Memorandum

Subject: Midgard Self Storage Facility – Plumbing Revision

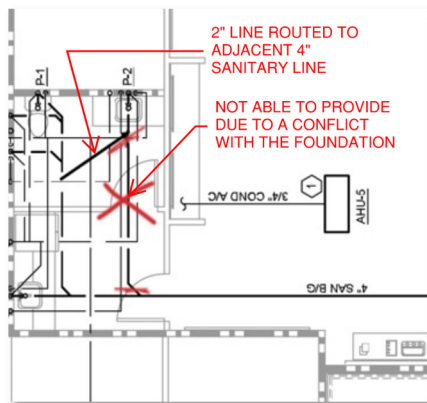
1. Per the approved permit drawings, restroom vanity was to have a 2" line running parallel to the sanitary for the water closet, but due to a foundation conflict, the line was routed to tie into the adjacent 4" line, refer to image below
2. The architectural design and engineering team have no objections to the installation and will update the contract documents for record.
